SITE PLAN REVIEW AND APPEARANCE BOARD STAFF REPORT

Delray Beach Ocean Club

Meeting	File No.	Application Type
November 9, 2022	2021-194-SPF-SPM-SPR-CL3	Class III Site Plan Modification
Property Owner	Applicant	Agent
Delray Beach Club Inc.	GE Architecture Inc./Gary P. Eliopoulos	GE Architecture Inc./Gary P. Eliopoulos

Consideration of a Class III Site Plan Modification, Landscape Plan, and Architectural Elevations for Delray Beach Club, located at 2001 South Ocean Boulevard, associated with the construction of a one story covered parking garage (17,243 SF) with two rooftop tennis courts.

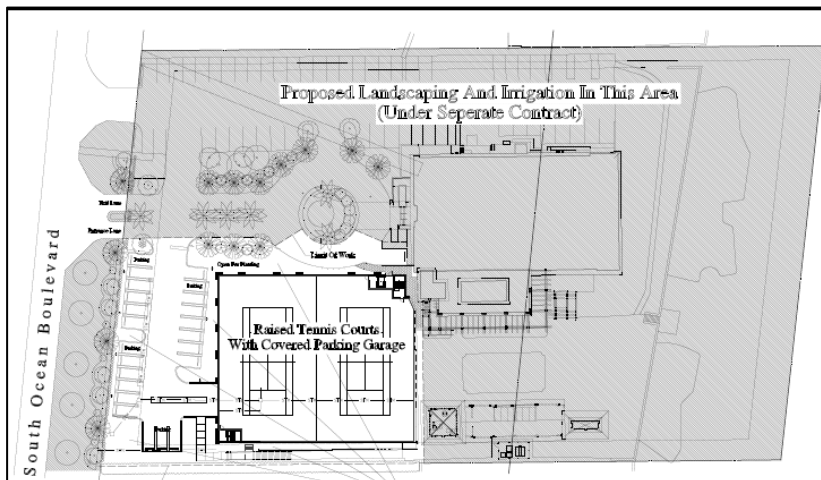
The landscaping for the Delray Beach Club is being completed with each of the approved phases. The current proposal is phase four while the other three phases are part of an approval for the front entrance and along the rear yard between the existing club house building and the dune vegetation that was approved by SPRAB in June 2022. (See plan to the right that indicates all the shaded area as Phase One - three).

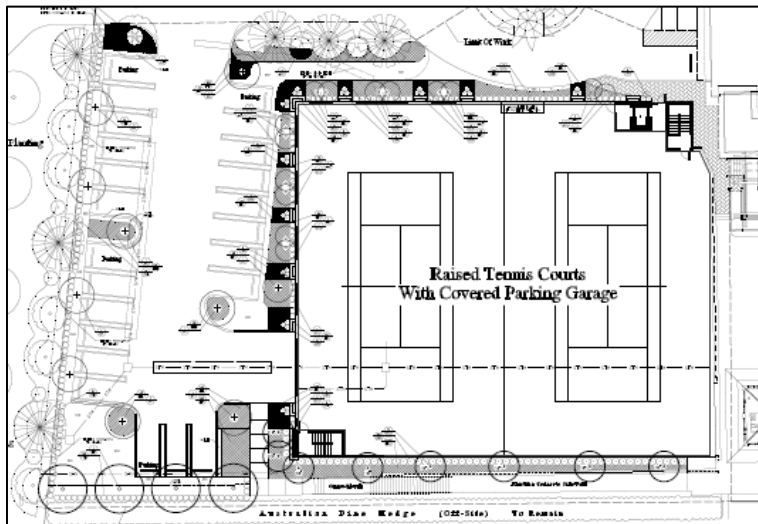
The proposed, phase four landscape plan was reviewed by staff for compliance to **LDR Section 4.6.16: Landscape Regulations**. Pursuant to **LDR Section 4.6.1.6(H)(3)(d)**, a five-foot landscape strip has been provided along A-1-A and on the south side of the property adjacent to the parking lot and abutting residentially zoned property. The landscape legend provided on LP-3 calculates the required interior landscaping and the total number of trees that are required.

The tree mitigation is provided on TD-1, which indicates the relocation and removal of Palms and Trees. Phase Four mitigation is contingent on the completion of the first three phases. Pursuant to **LDR 4.6.19(C)(2)(c) Vegetation removal permits for development applications**, a condition assessment (See Appendix "A" for definitions) for all trees performed by a certified arborist that describes the condition percentage rating of the tree, makes note of hazardous trees and identifies trees that are a threat to endanger structures, pavement, and/or utilities. Those trees that are identified to be relocated will require a written assessment of transplant feasibility. The tree mitigation cannot be completed on phase four until the first three phases have been completed. Given the improvements required by the prior phases that are within the limitations of Phase Four, the arborist report for phase four will be provided at the time of building permit and is noted on the site and landscape plan. If the report determines that the existing trees require mitigation, then a site plan modification will be required to address the insufficiency and will need to provide the sufficient height, clear trunk, DBH, and condition rating.

1. Prior to building permit issuance, a landscape arborist report for Phase Four will be required to be submitted and reviewed for compliance.
